Justification for Class III Permit Modification March 2006 SWMU 101 Operable Unit 1295 Building 9926/9926A Septic System and Seepage Pit (Coyote Test Field)

Building 9926/9926A Septic System and
Seepage Pit (Coyote Test Field)

RSI Response Submitted June 2005

**REQUEST FOR SUPPLEMENTAL INFORMATION
RESPONSE AND PROPOSAL FOR
CORRECTIVE ACTION COMPLETE FOR
DRAIN AND SEPTIC SYSTEMS SWMU 101,
BUILDING 9926 EXPLOSIVE CONTAMINATED
SUMPS AND DRAINS,
COYOTE TEST FIELD**

Figure 1-2: ER Site 101 Site Map

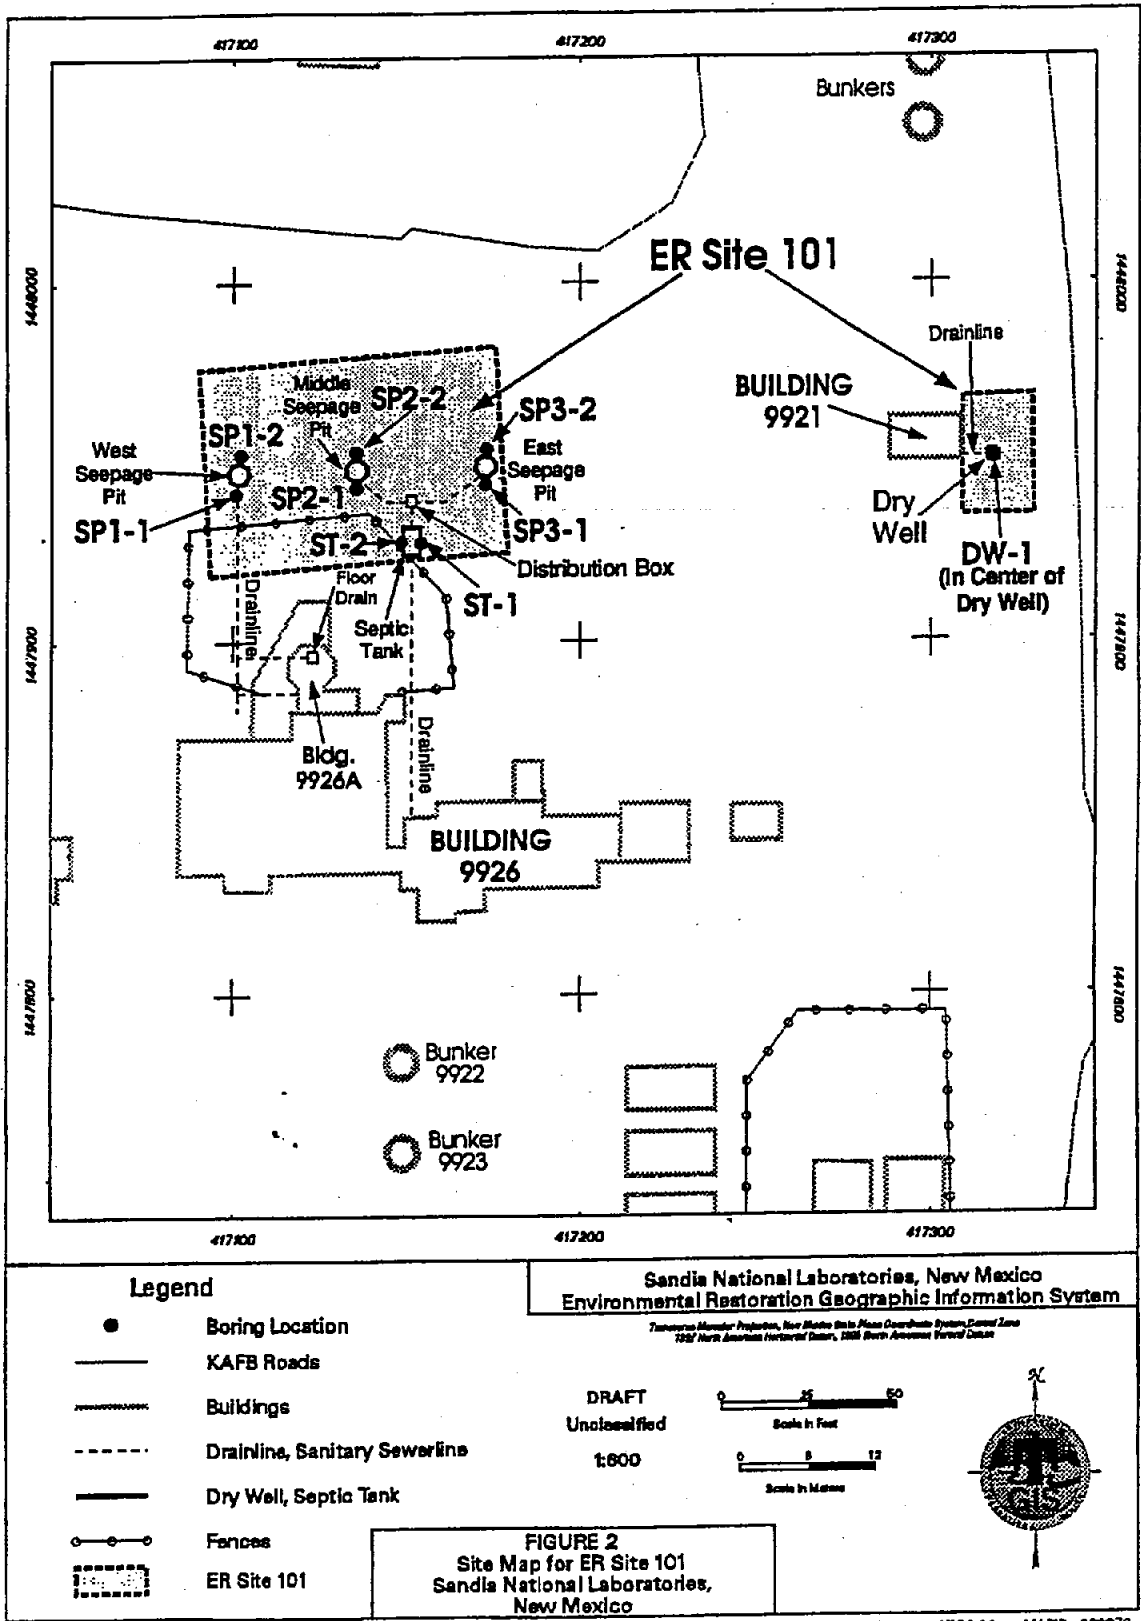
16. Figure 1-2 is apparently misreferenced as Figure 2-2. Also see General Comment 1.

Response: The NMED is correct. Figure 1-2 is misreferenced as 2-2 several times on page 2-2. Also, see response to General Comment 1.
